ADDENDUM NO. 1

Renovation to Exterior/Interior RC Building Warrensburg Readiness Center Warrensburg, Missouri PROJECT NO.: T2306-01

May 17, 2024

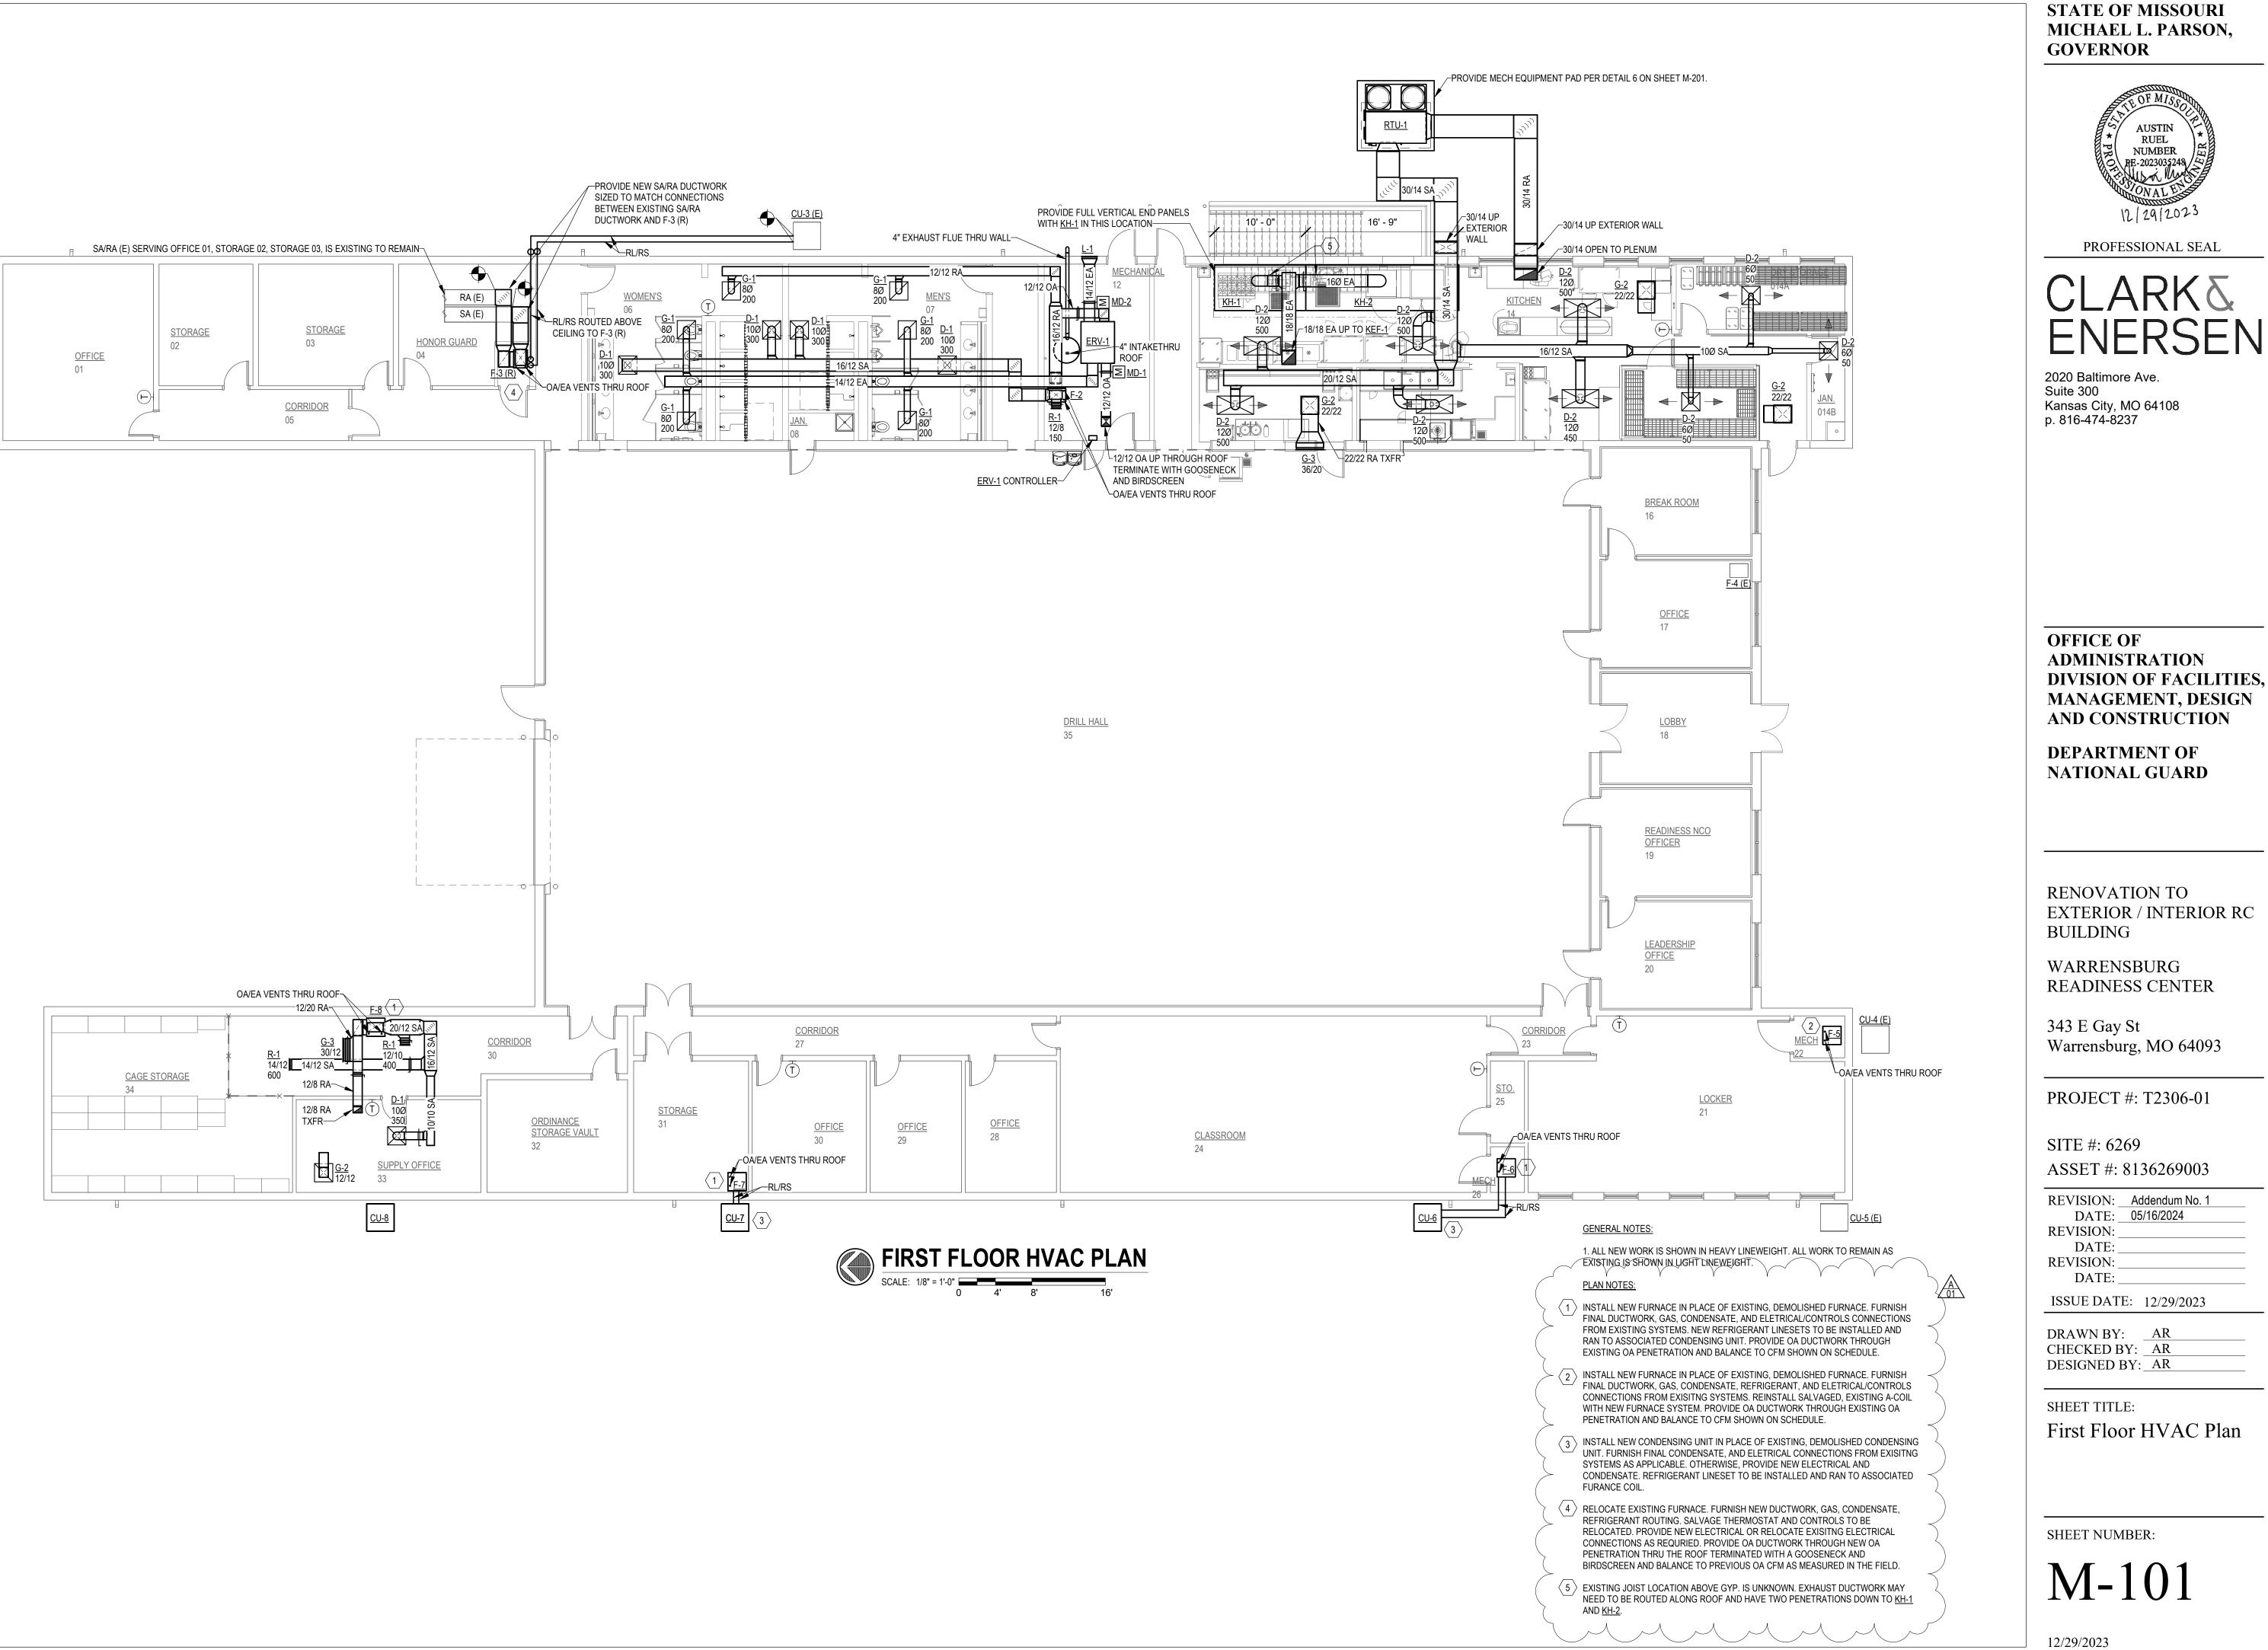
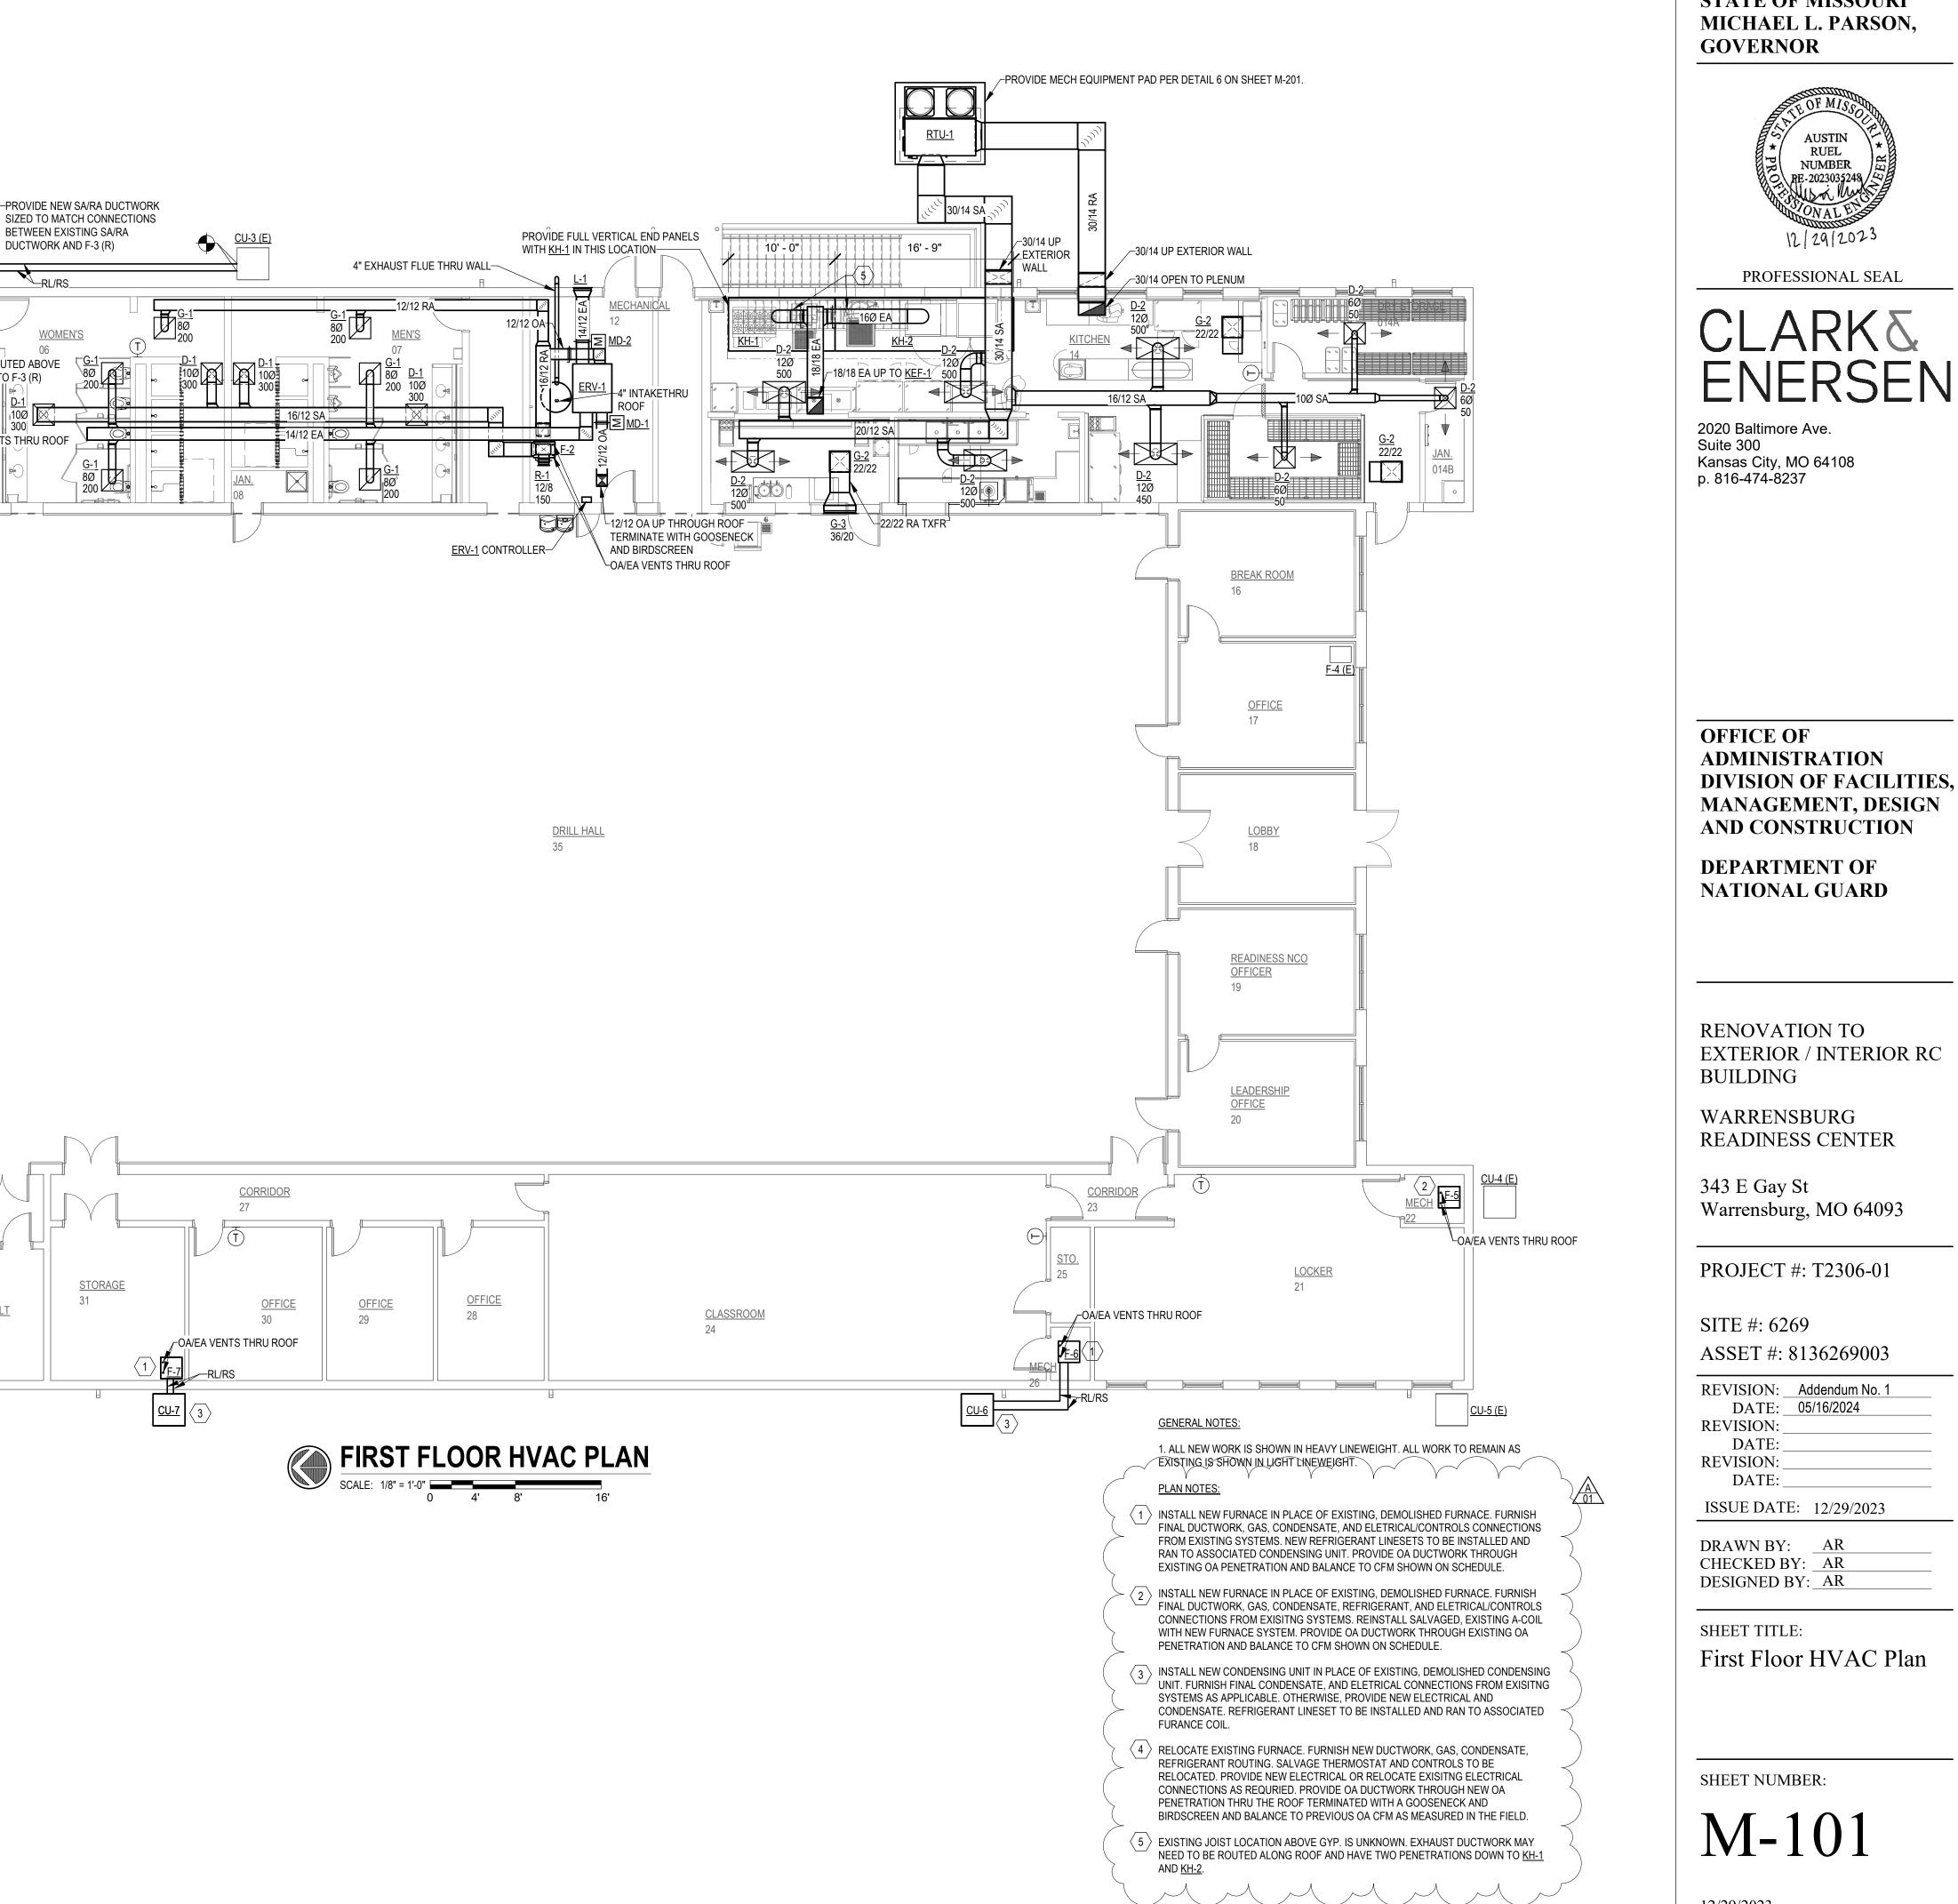
11. Sheet M-101 (attached)

a. REVISE Plan Notes 1, 2, and 4 to include outside air ductwork scope description for demolished, new, and relocated furnaces.

FIRST FLOOR PLUMBING PLAN SCALE: 1/8" = 1'-0 4' 8'

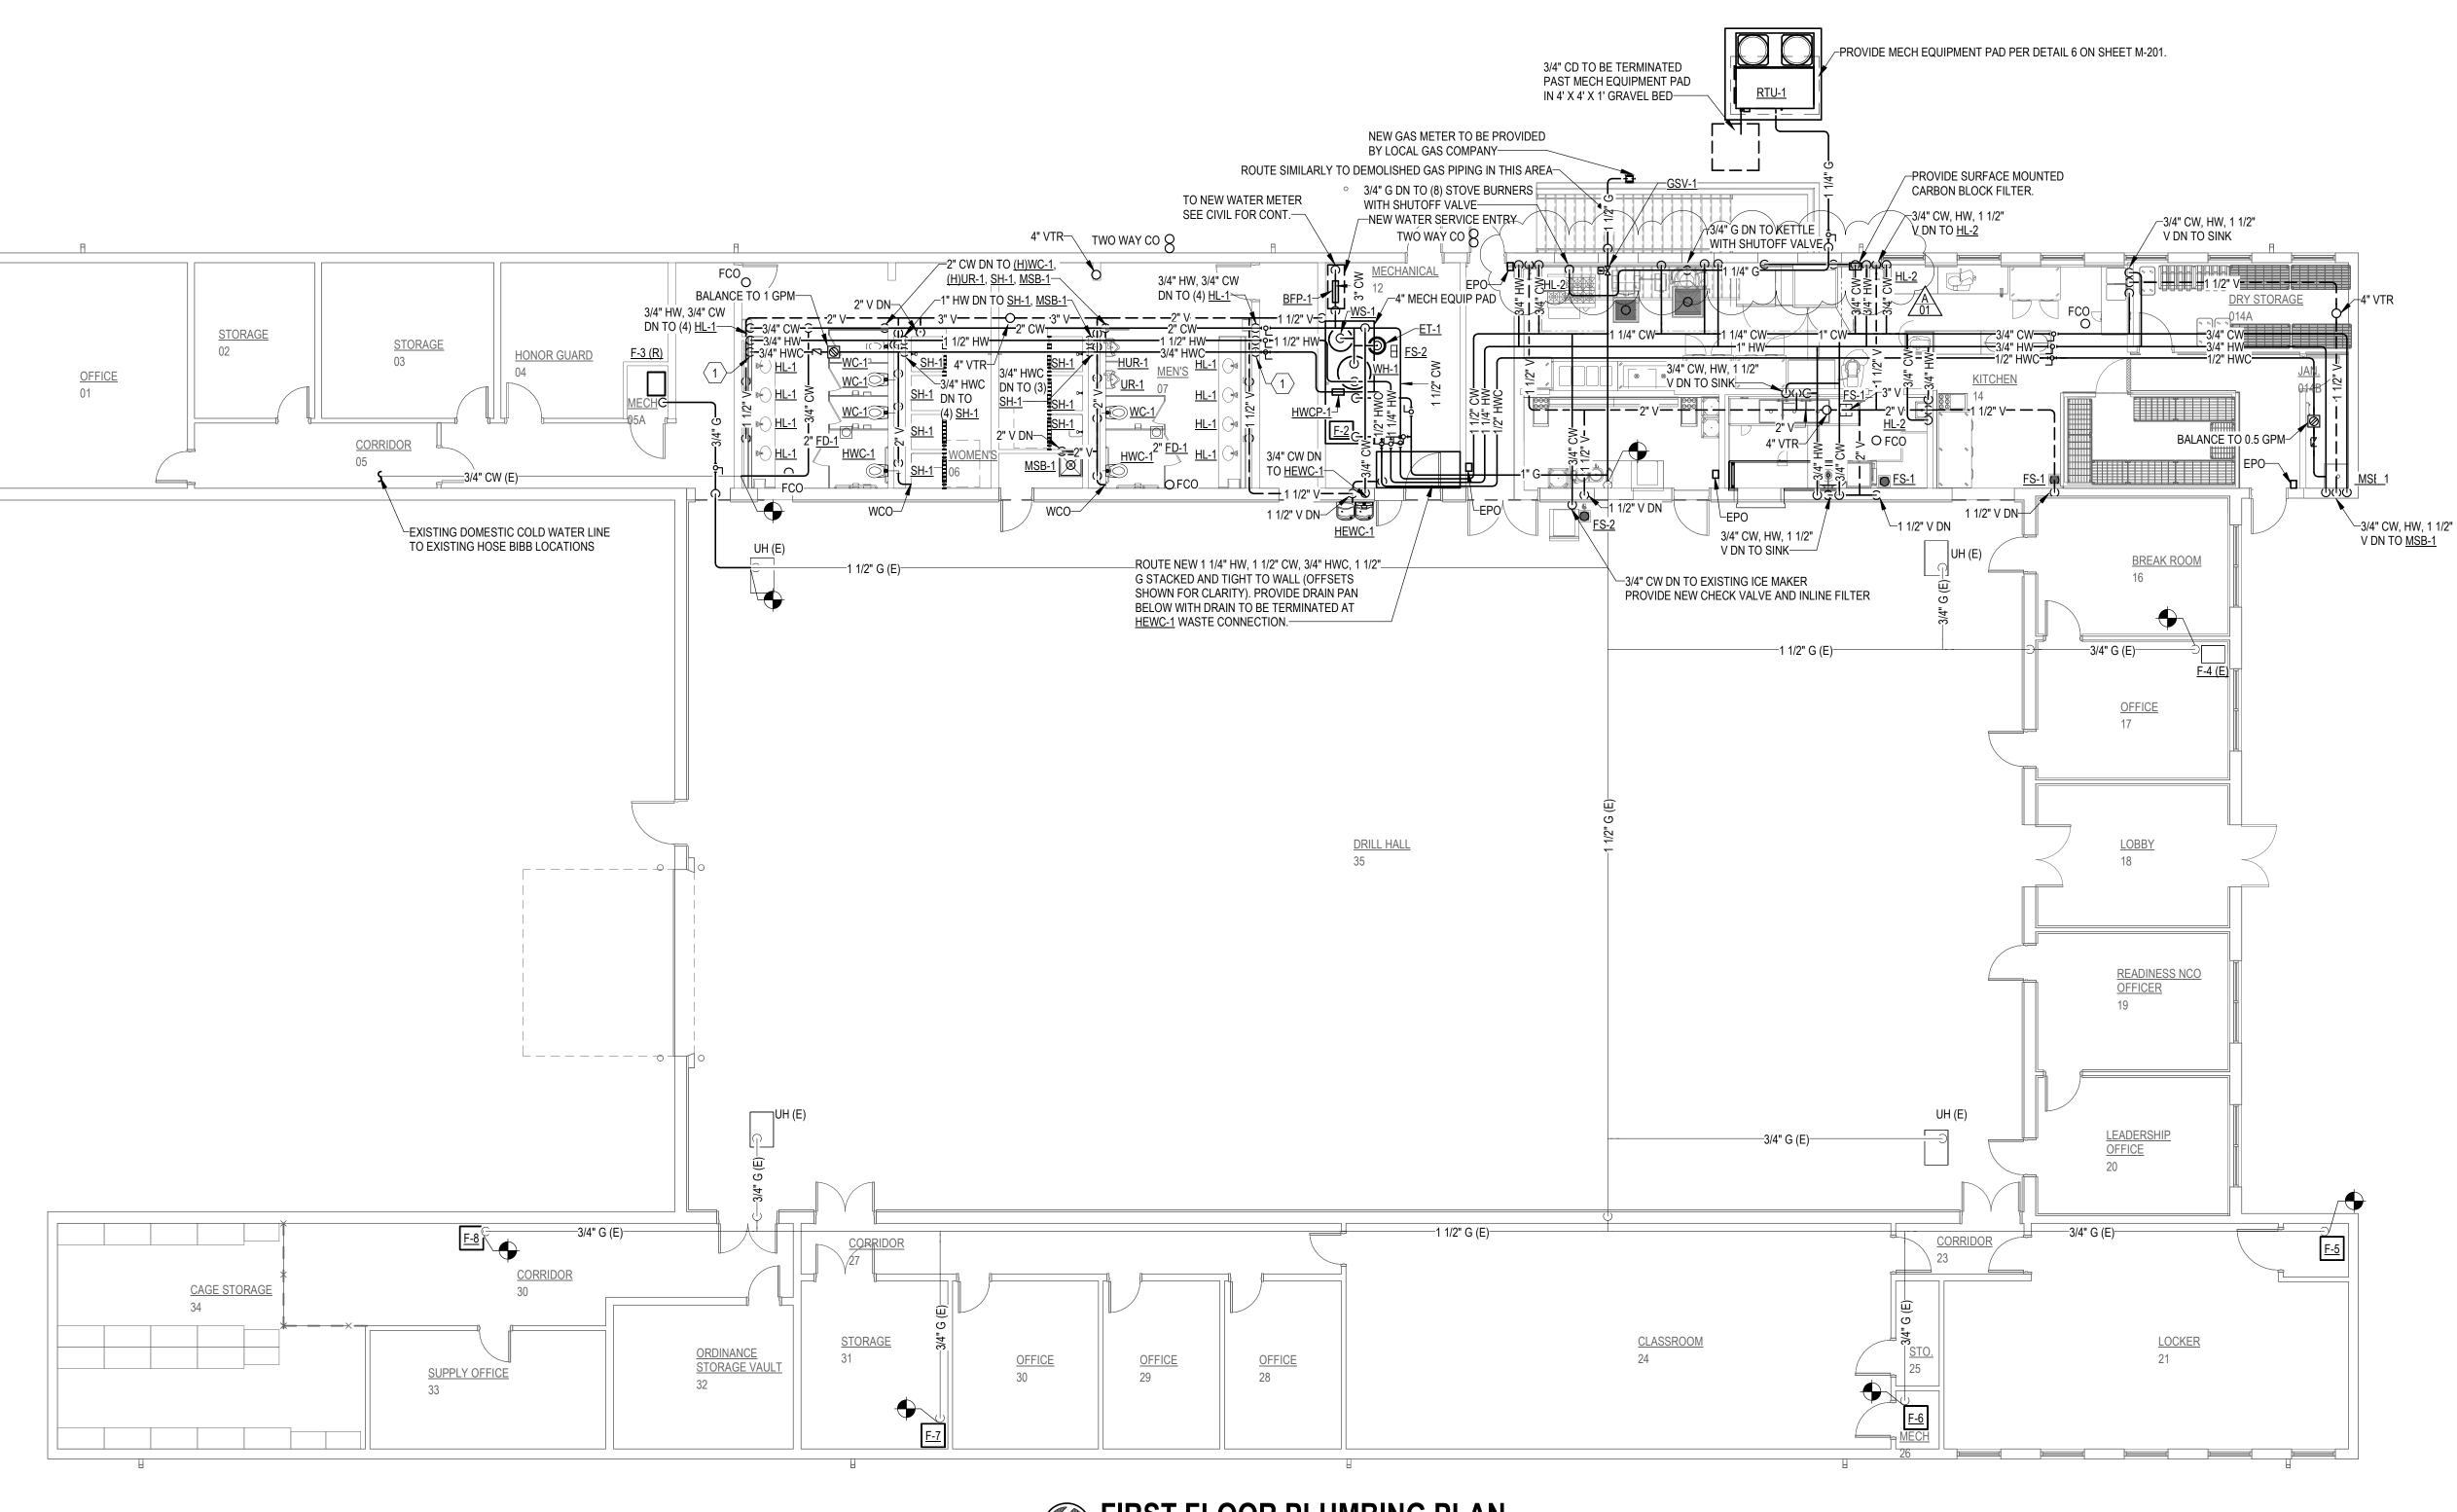
12. Sheet P-102 (attached)

a. REVISE Plumbing piping along hood wall to be routed down 3 5/8" fur-out added in Addendum No. 1.
